Access Compliance Report

Public Rights-of-Way

(Curb Ramps)

Intersection ID: 3272	Main Street: HIGHCROFT_LN	Cross Street: WORSLEY_LN	Location: NW
ADA ID: 0C082CCE9B38	Ramp Type: Perp	Initial Pass/Fail: Fail	Overall Compliance: No
Severity Score: 8.75			
Codes/Mitigation Info/Possible Solution		Field Measurements/Component Compliance

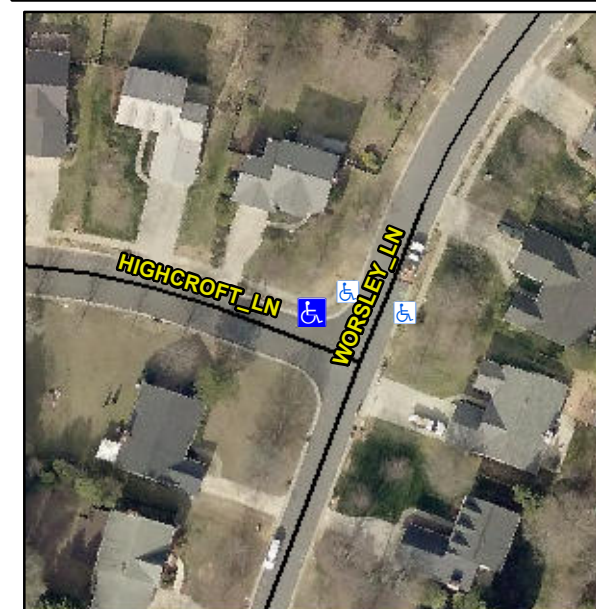
PROW/ADA:

Not Found, R304.5.1

Possible Solutions:

Remove & Replace Entire Ramp.
